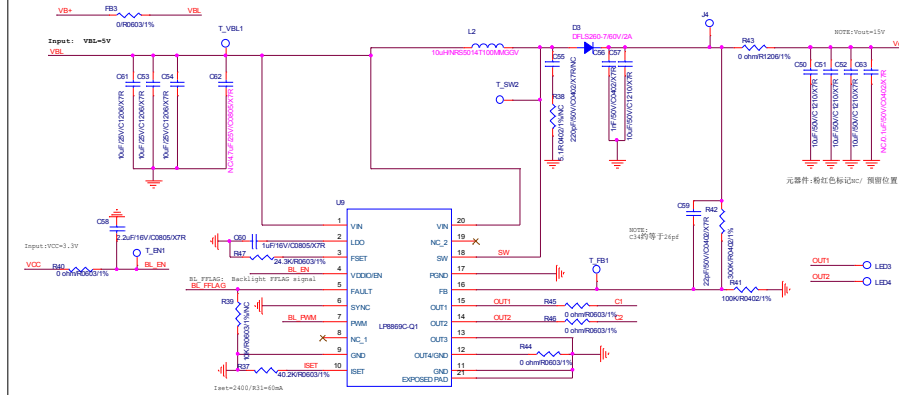
L1 closed to D2 and under L1 can not layout

NOTE: Components L1/R22/R24 /R20/R21/C33/C34 closed to U4
